PCD-ENGINEERING REVIEW COMMENTS
IN BLUE BOXES WITH BLUE TEXT

FINAL DRAINAGE REPORT
for
WINDERMERE FILING NO. 1

January 4, 2022

SF-21-026

DR2
 SHEET: 2 OF 5

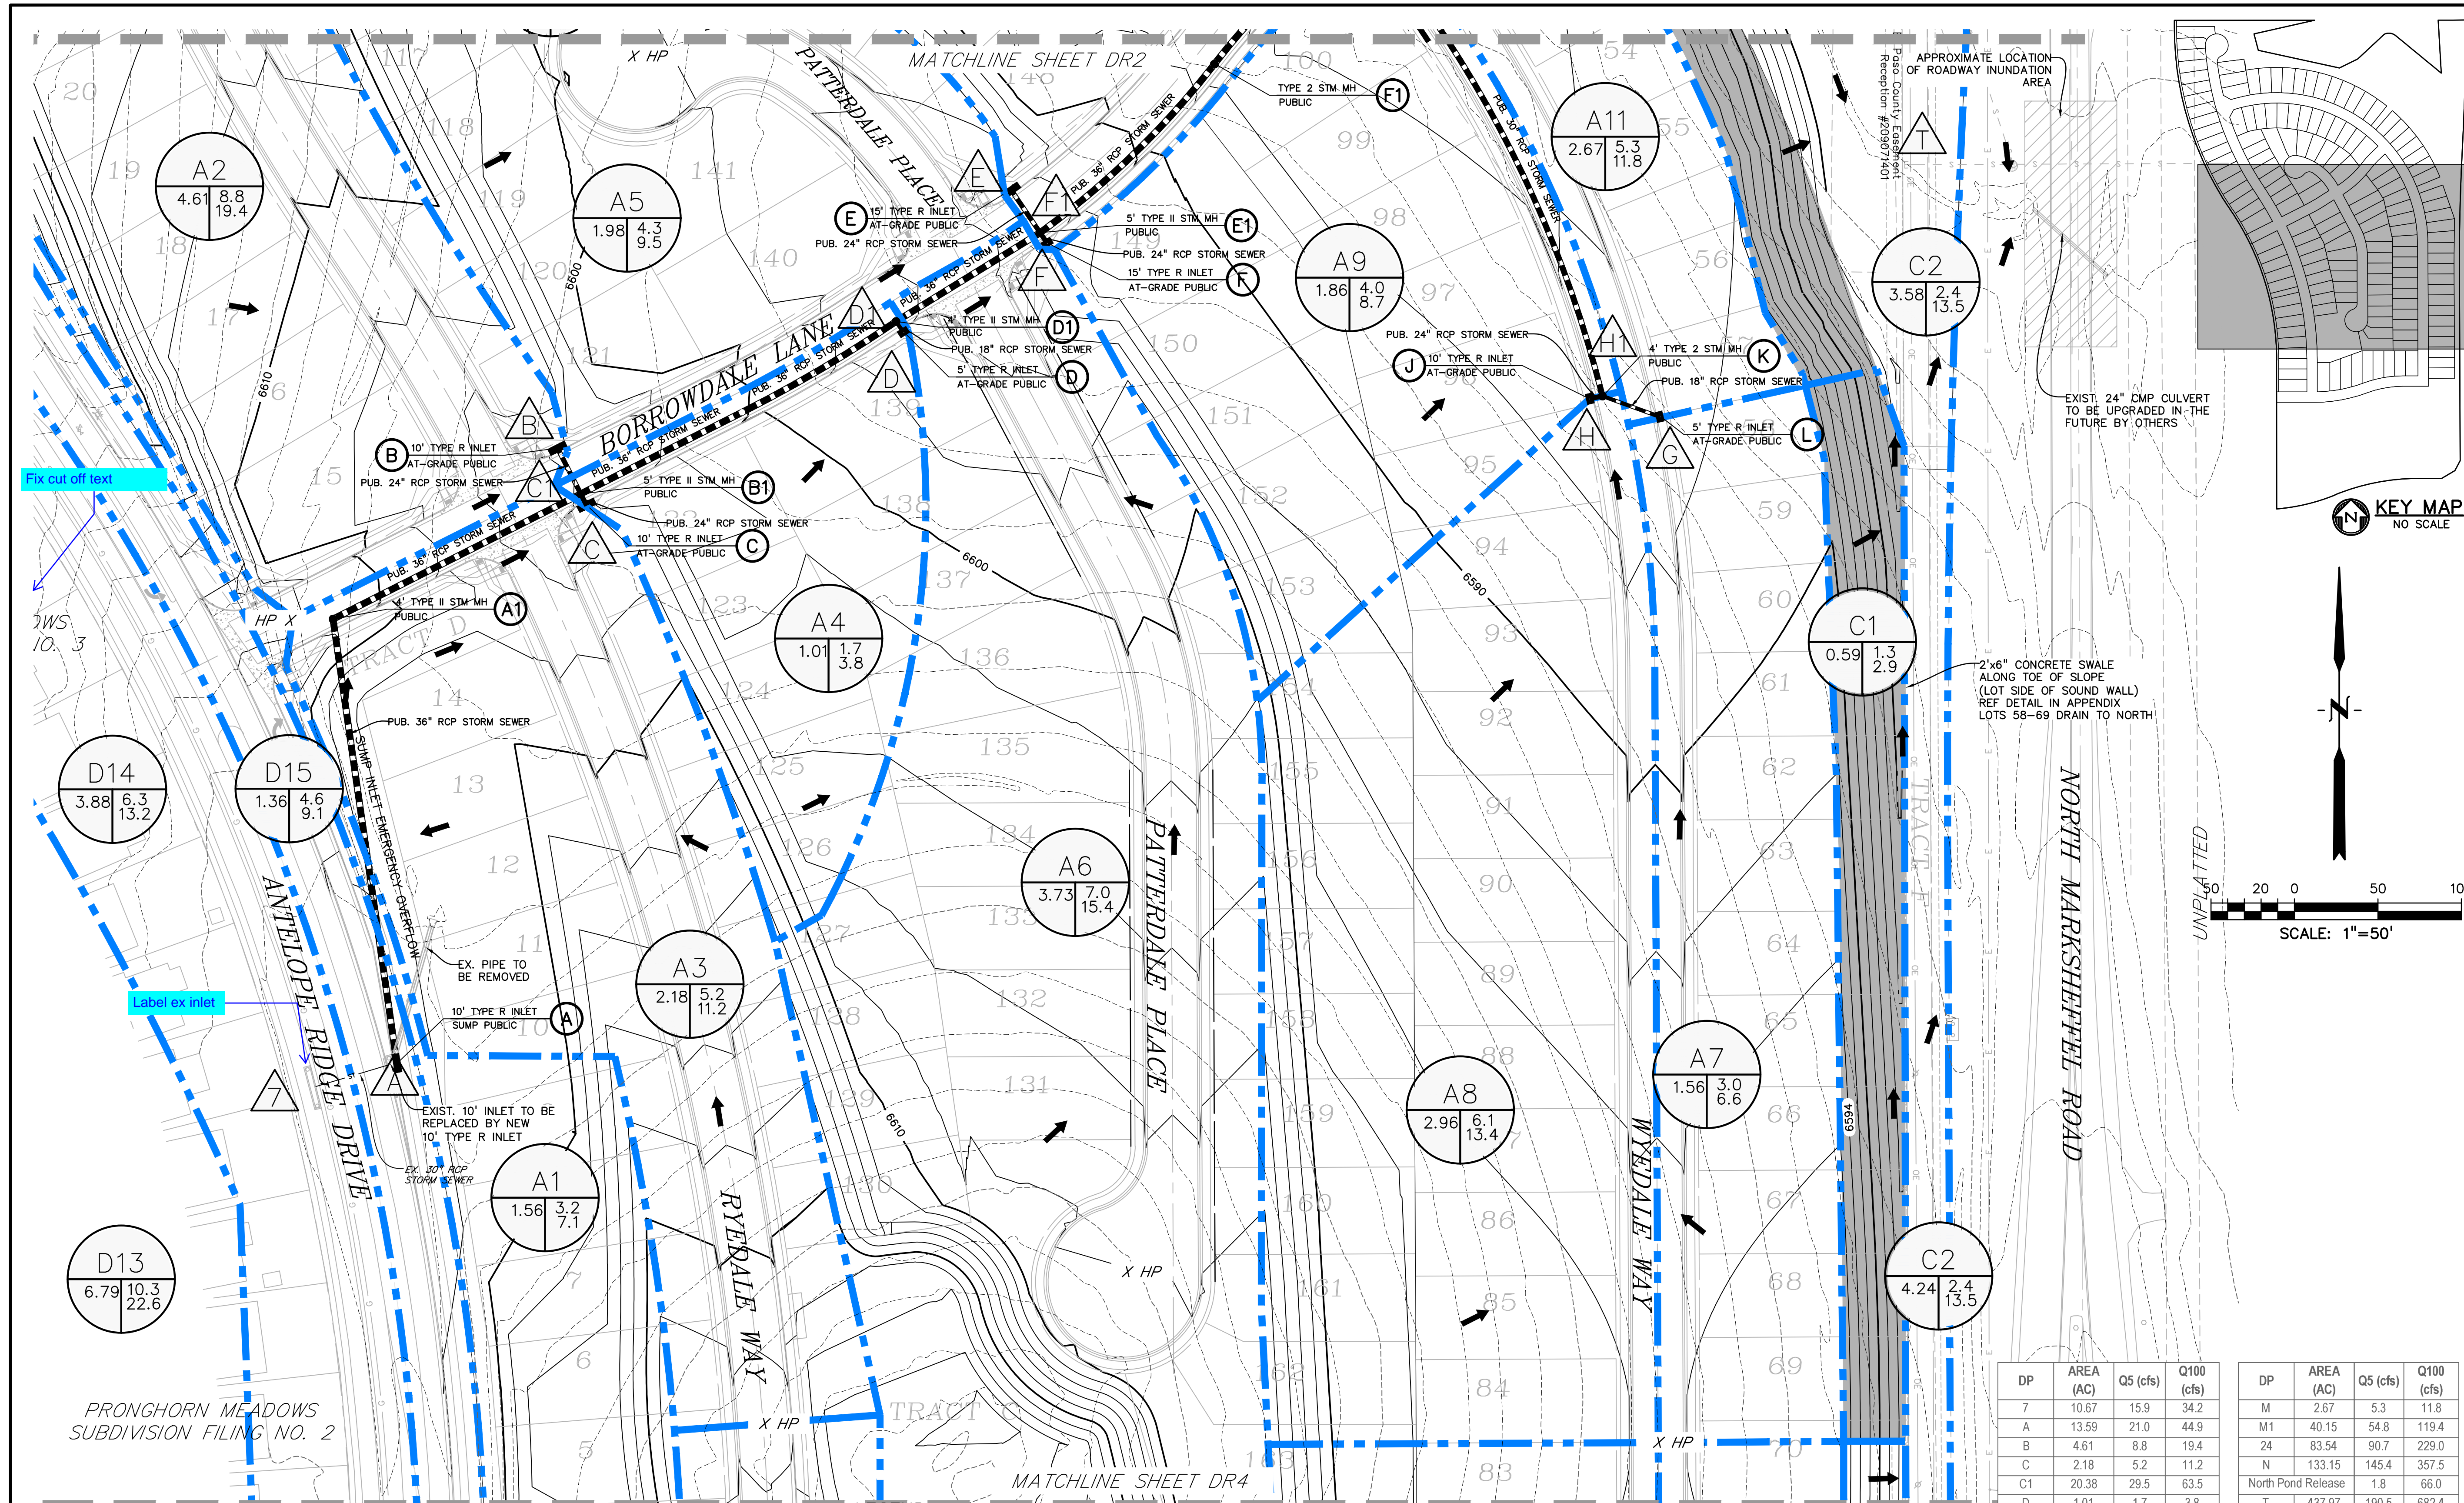
How is access for maintenance being achieved for this forebay?

UDSewer has pipes still listed as 43x68 ellipticals. Please coordinate between design and plans.

What is radius? Maintenance access needs to be within 25' of all forebays, outlets, etc.

Missing pipe size

Delete

Label ex inlet

SHEET: 4 OF 5

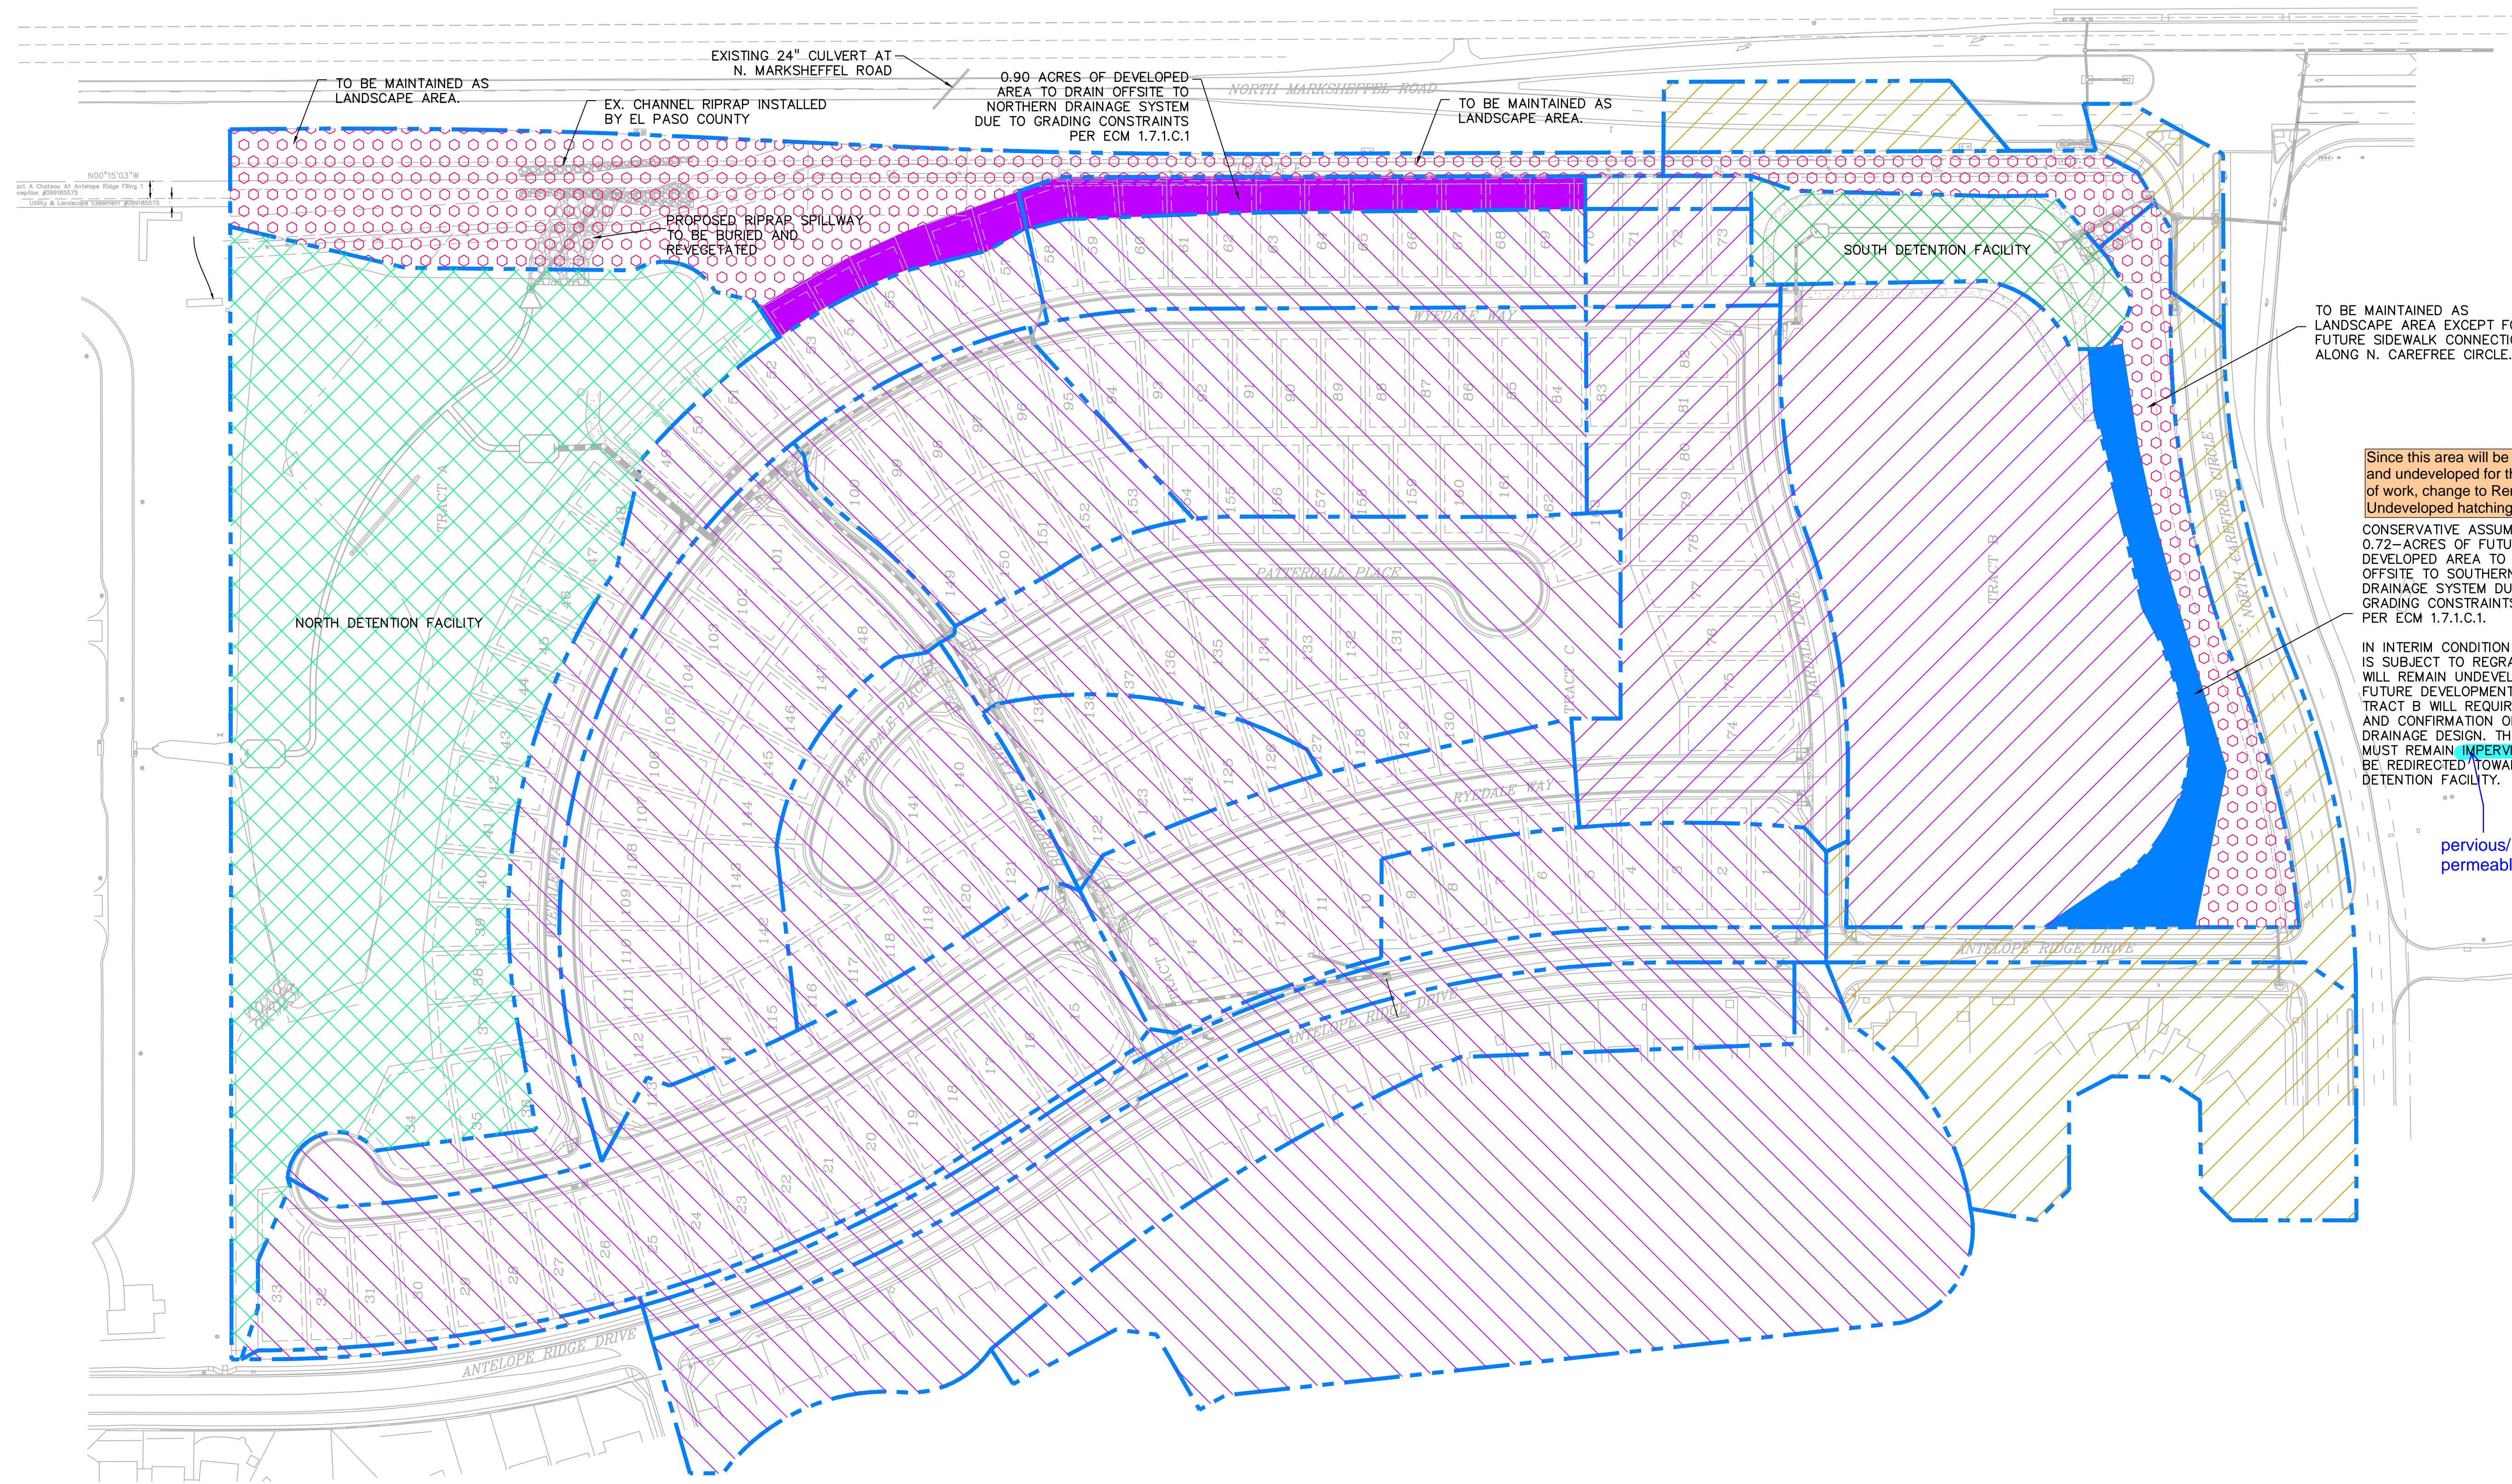
Since this area will be graded and undeveloped for this phase of work, change to Remaining Undeveloped hatching.
